SUBJECT: Forwards addl info re 870123 application for amends to
 Licenses NPF-41, NPF-51 & NPF-65, reducing boration
 requirements when in shutdown, per 870303 telcon & 870401
 ltr.

Subject: Palo Verde Nuclear Generating Station (PVNGS)
Units 1, 2, and 3
Docket Nos. STN 50-528 (License NPF-41)
STN 50-529 (License NPF-51)
STN 50-530 (License NPF-65)
Revision to Technical Specification Amendment
Sections 1.0, 2.2, 3/4.1, 3/4.3, 3/4.10
File: 87-F-005-419.05; 87-A-056-026

ATTACHMENT 1
ANPP RESPONSE TO NRC REQUEST FOR ADDITIONAL INFORMATION

Figure 1-1

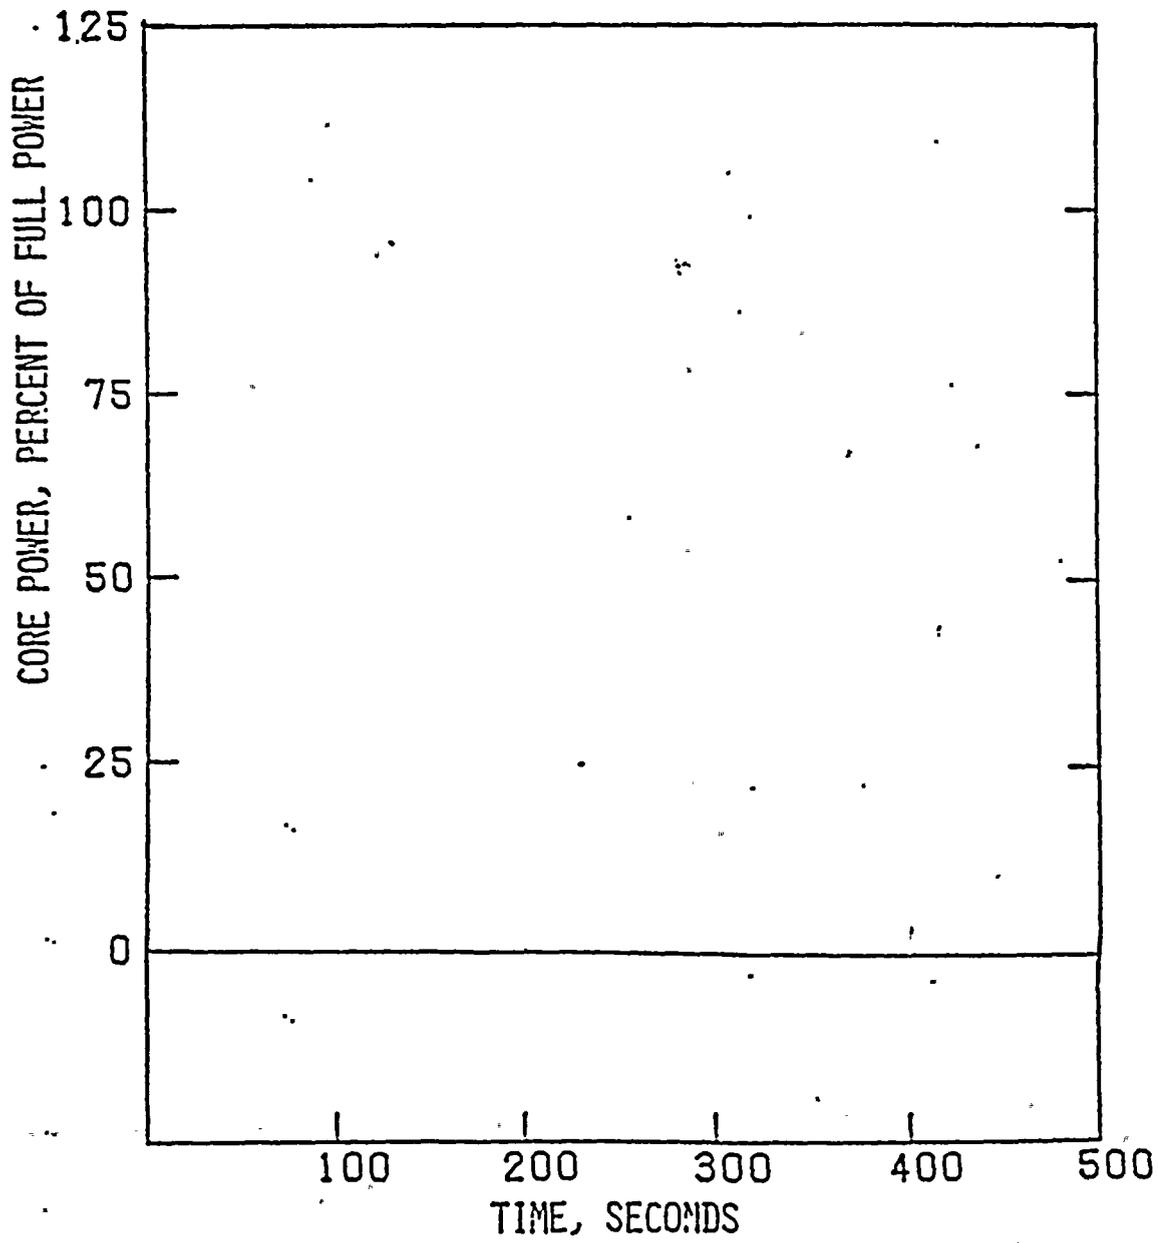
Many of the Figures accompanying the supporting analyses for the Technical Specification amendment request are unlabeled and some are also completely blank (e.g., Fig. 1-1, Fig. 1-2, Fig. 1-15). Please correct and update these.

Section H of the attachment to Reference (1) supplied the supporting analyses for the Technical Specification amendment request. Figures 1-1, 1-2, and 1-15 showed core power, core heat flux, and safety injection flow, respectively, as a function of time. These figures were for a large steam line break during Mode 3. As would be expected for Mode 3, core power and core heat flux are zero for the duration of the transient. In addition, the analysis states that during the first 500 seconds of the transient the pressurizer pressure remains above the Safety Injection Actuation Signal setpoint. Therefore, safety injection flow is also zero for the duration of the transient. These figures were originally scaled such that the curve was superimposed on the horizontal axis and it appeared that the curve was omitted from the figure. To facilitate the review of this amendment request, the figures have been rescaled such that the curves do not lie on the axis. Similarly, Figures 1-17, 1-18 and 1-31 have also been rescaled.
